RESPONSE TO SUBMISSIONS SSD 10352

Moriah College
Staged Redevelopment

Figure 4 Comparison of submitted and amended proposal from intersection of York Road and Baronga Avenue

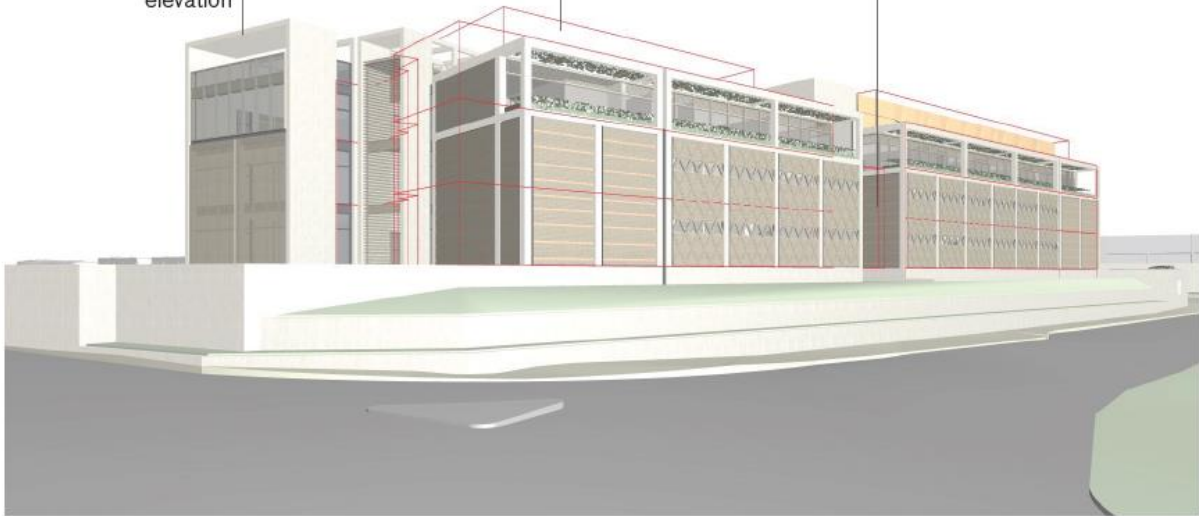
The extent of the reduction in building height and scale is demonstrated in Figure 4 and Figure 5. The overall height of the building has been reduced from that submitted with the original SSDA. The level 4 plant volume at the southern wing of the building has been setback further from the eastern boundary along Baronga Avenue. This creates a more recessive appearance from when viewed from the surrounding parklands.

- Northern wing is setback to reduce bulk on Baronga Avenue. Façade is simplified.
- Level 4 plant is setback, reducing bulk on Baronga Avenue.
- Level 3 is setback, further reducing bulk on Baronga Avenue.
- Clear separation of forms through increase indent to courtyard on Baronga Avenue reduces overall scale of the Stage 1 building.
- Clearer articulation of the built form and façade expression reduces perception of scale to the York Road elevation.

Clearer articulation of the built form and facade expression reduces the perception of scale to the York Road elevation

Overall reduction in bulk of eastern facade is further enhanced by the setback plan

Clear separation of forms reduces overall scale

Figure 6 Amended Stage 2 building envelope south-west perspective

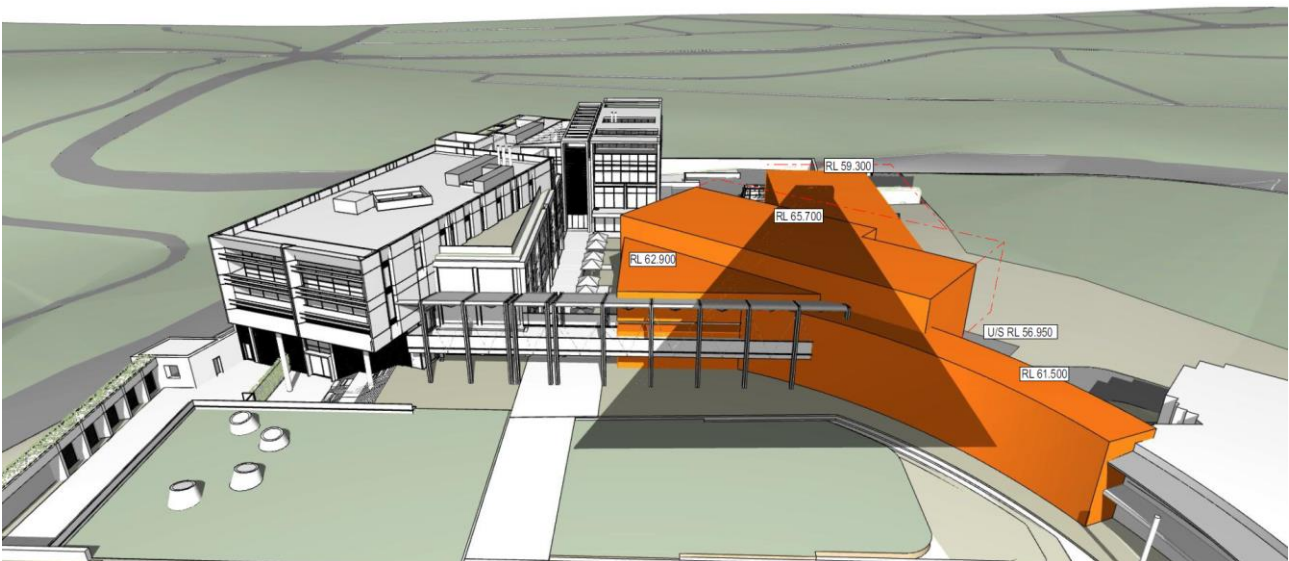
A comparison of the submitted and amended proposal for the Stage 2 building envelope is provided at Table 3. The extent of the reduction in building height and scale is demonstrated in Figure 6 and Figure 7. The building envelope has been further setback to the south and west to ensure there is no overshadowing of the Eastern Suburbs Banksia Scrub located on the adjacent lot. This has resulted in an overall reduction in GFA and a more refined three-dimensional building envelope.

Note: overlaid red line indicates original SSDA proposal

Figure 11 Existing (left) and proposed (right) overshadowing at 9am – 21st of June

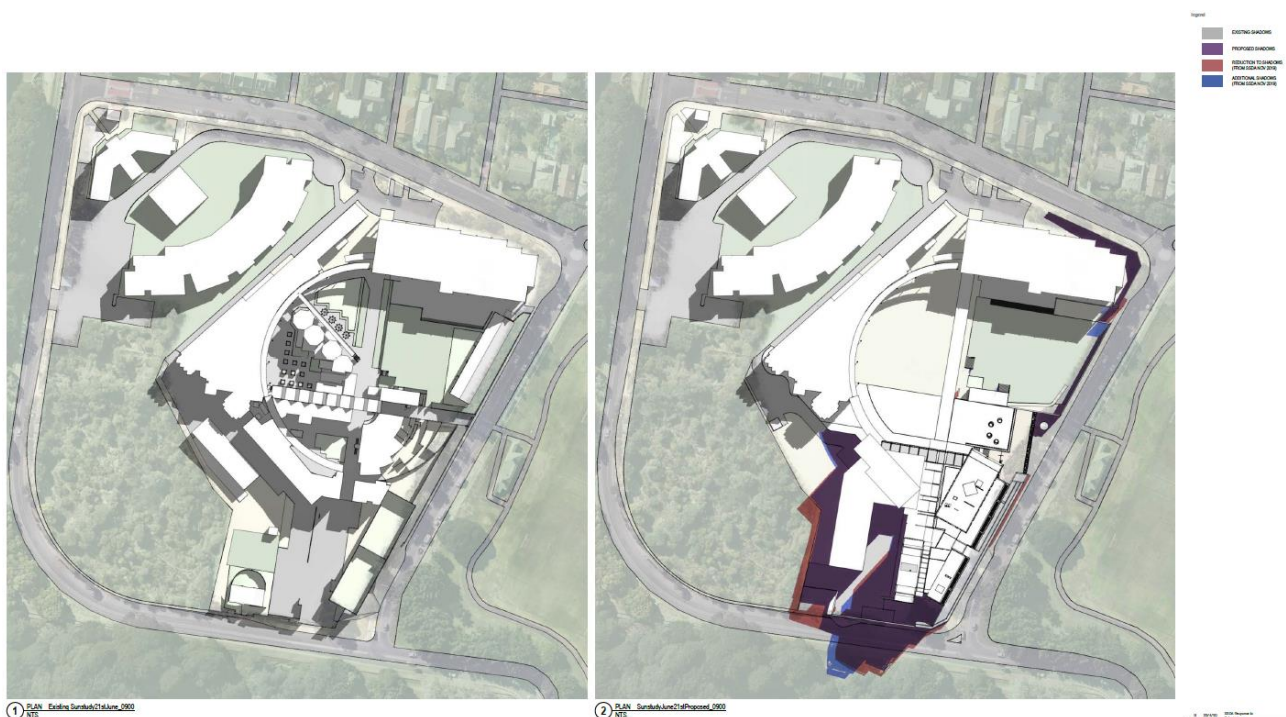
Submission	Response
<u>General</u>	
<i>Provide updated shadow diagrams that correct discrepancies between the shadows generated by existing buildings on 'Existing Sunstudy21stJune' plans and shadows generated by existing buildings on 'Proposed Sunstudy21stJune' plans.</i>	This error has been corrected in the amended Architectural Plans and Urban Design Response at Appendix A .
<u>Built form and urban design</u>	
<i>Provide information that details whether an option analysis was undertaken in the design stages of the proposed development, including consideration of options to reduce massing on the eastern boundary adjacent to Queens Park.</i>	<p>A detailed options analysis has been provided in the Urban Design Response at Appendix A. A total of four massing options were considered by FJMT during the design development stage. These options built on the previous work undertaken by Gardner Wetherill Associates, who developed a School Master Plan over a period of 25 years since its original construction in 1994.</p> <p>In response to submissions received the Baronga Avenue (eastern boundary) massing and façade treatment has been further refined to reduce bulk and scale. The design has been further resolved to provide a highly articulated and engaging façade contributing to both the public domain and the embodiment of the culture of the college.</p> <p>The roof top plant zone to the western form has been setback substantially from Baronga Avenue reducing the overall bulk when viewed from both Queens Park and Centennial Park. The northern form of the western wing has been further articulated to provide a finer grain detail and to be also read as a clear part of a whole. This further reduced the bulk and scale from a more monolithic form to a collection of forms.</p>

FJMT have prepared an updated overshadowing analysis of the amended design on the winter solstice from 9am to 3pm (refer **Appendix A**). An error identified by DPIE in the submitted plans has also been corrected.

Reduction in bulk and scale of the Stage 2 Building envelope have resulted in no additional overshadowing to the ESBS when compared to the existing environment.

Figure 15 Area of the site to be included in the terrestrial biodiversity map

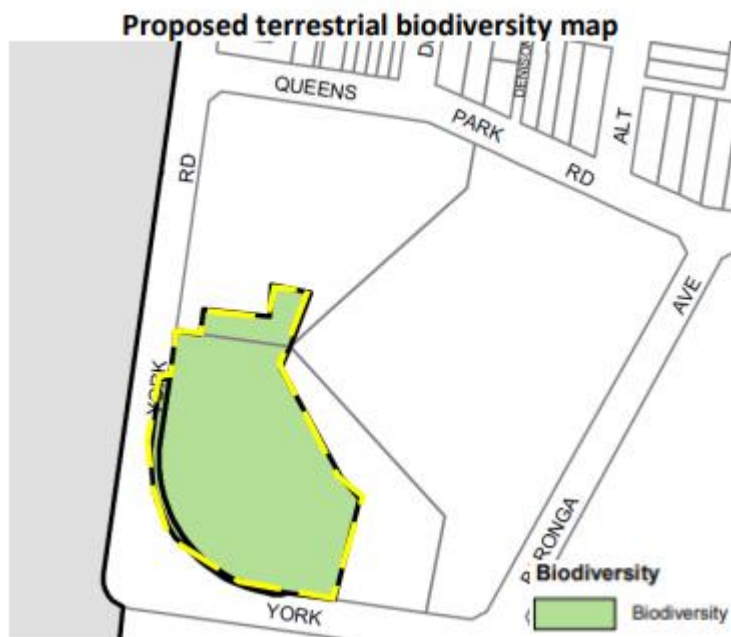
Submissions	Response
<p><i>The EIS should confirm whether the proposal will involve work on land that is identified on the Terrestrial Biodiversity Map under Clause 6.4 of the LEP.</i></p> <p><i>For information, the DPIE issued Gateway Determination on 3 October 2019 for a Planning Proposal which seeks to rezone a portion of Lot 1 in DP701512 and a very small portion of Lot 22 in DP879582 and Lot 3 in DP701512</i></p>	<p>The proposal will not involve work on land that is identified on the Terrestrial Biodiversity Map. Refer to Section 6.3 of this report.</p>
<p><i>The EIS should consider the draft Waverly Local Strategic Planning Statement where relevant</i></p>	<p>Refer Section 6.2 of this report.</p>

Council exhibited the planning proposal in March 2020. The planning proposal (as amended) no longer seeks to rezone the selected land of the Moriah College site to E2 as the zone would be too restrictive to the operation and growth of the school. Instead this portion of the site is proposed to be protected by way of the terrestrial biodiversity map which is subject to the provision of Clause 6.4 of the LEP (refer **Figure 12**).

As detailed in **Figure 11** the proposed works are restricted to Lot 22 in DP 879582 and Lot 3 in DP 701512. In addition, no clearing of ESBS is proposed. Therefore, Clause 6.4 of the LEP would not apply to the site following the finalisation of the planning proposal (as amended).
